REF: N168210

DATE: 18 December 2020

RE: 338 PITT STREET, SYDNEY – RESPONSE TO STAKEHOLDER SUBMISSIONS

GROUND FLOOR
VEHICLE SWEEP PATH ASSESSMENT

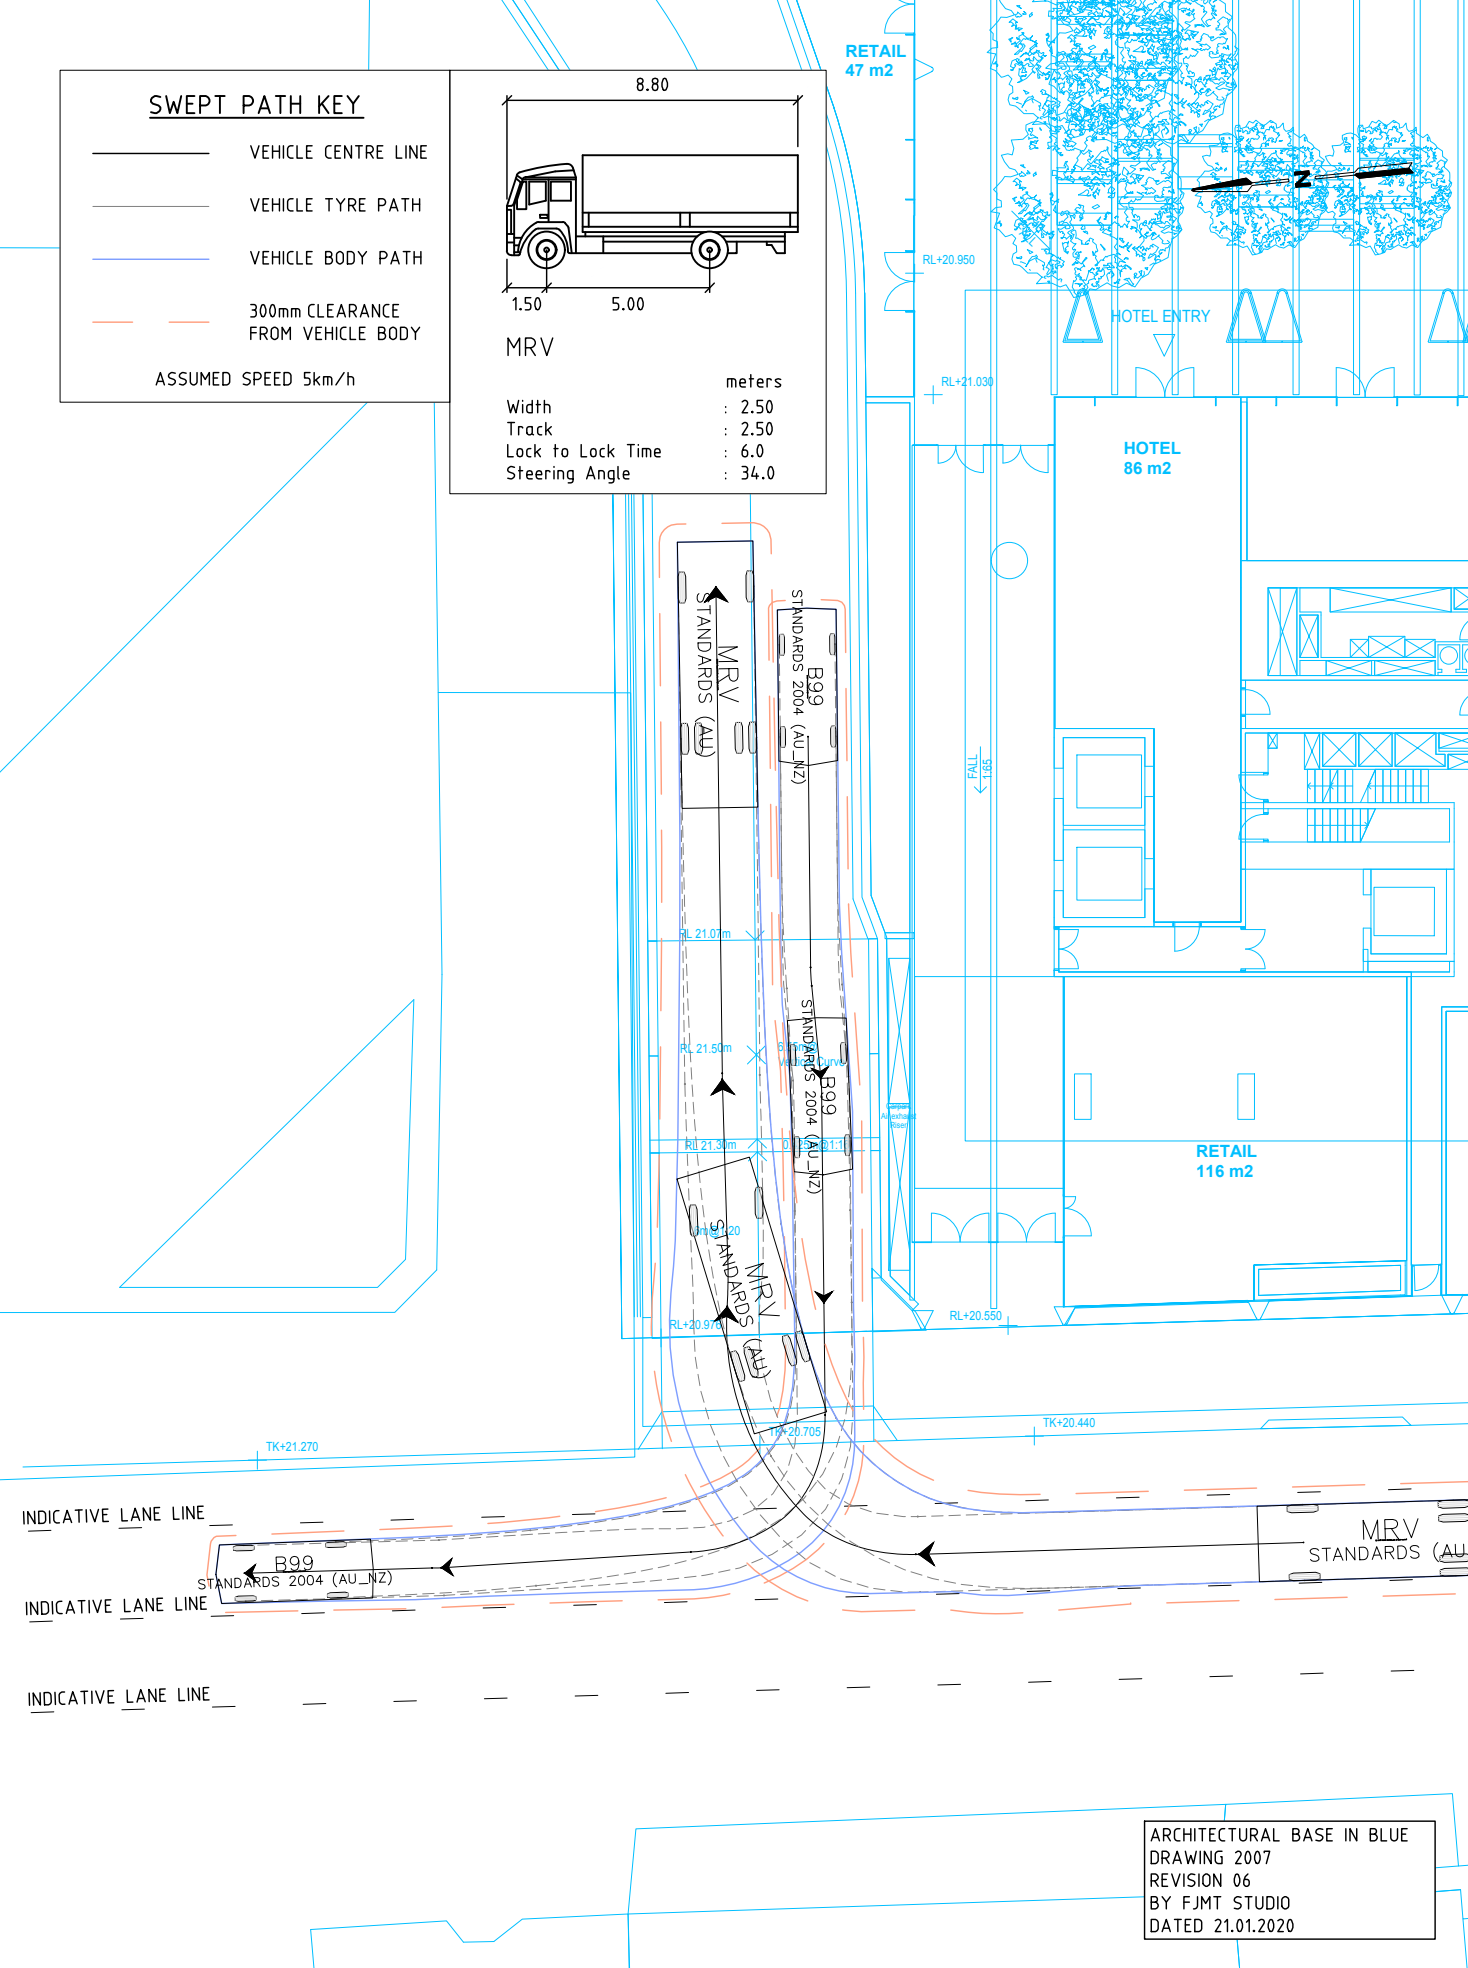
21. The driveway crossover should be reduced in width – its current width will adversely impact the safe and efficient passage of pedestrians on Pitt Street. The crossover is to be reduced in size having regard to Section 3.11.11 of the Sydney DCP 2012.

Given Pitt Street is also one-way northbound, all vehicles would turn right on entry and right on exit. This results in the crossover of vehicles when entering and exiting. While this is not ideal, it is also not uncommon in CBD locations where there are a greater proportion of one-way streets. Such access arrangements result in the need to facilitate trucks and cars in the same access, with sufficient width to allow the passing of entering and exiting vehicles at the access point.

GTA prepared vehicle swept paths as part of the submission. This included 8.8-metre long MRVs, with updated swept paths included in Attachment 1. As shown, the driveway currently provides for two vehicles to appropriately pass however is not recommended to reduce the driveway crossover width any further than that documented.
